Solution K76992557

Title (customer effect) Chassis Experiencing High soot Accumulation, Abnormal (Too High, Too Low) Regeneration Temperatures Following An Aftertreatment Hydrocarbon Injector (AHI, 7th Injector) Nozzle Replacment Procedure

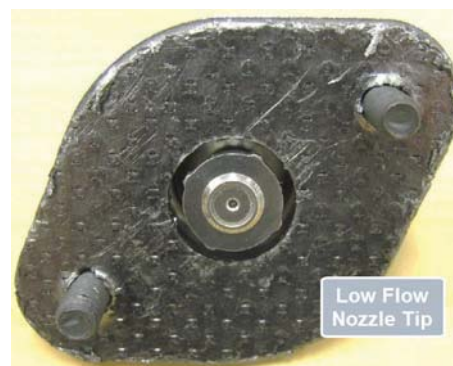
Cause Incorrect part number (P/N) AHI nozzle (7th Injector) could have possibly been installed.

- The low flow nozzle has been used for North American heavy duty engines since 2011. All US17 11L and 13L engines will now use the high flow nozzle (16L engines will continue to use the low flow nozzle).
- The AHI nozzle tip of the low flow and the high flow nozzle is different in appearance. Other than this difference, the two nozzles are visually the same.

Solution Model Year (MY) US17 changes to the AHI system have been made. MY US17 has been updated to a High flow nozzle.
